This Service Information bulletin supersedes SI B13 01 07 **dated August 2010.**

NEW designates changes to this revision

Fuel Injection and Induction System Cleaning

NEW Male Quick Disconnect Adaptor
P/N 83 30 2 158 083

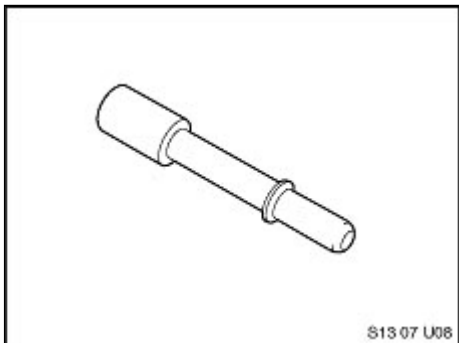
NEW Note:

Sent to all centers via Automatic Tool shipment in August 2010. Not included with the original kit, the adaptor must be ordered separately if additional kits are ordered. Refer to [SI B04 06 10](#) for more information.
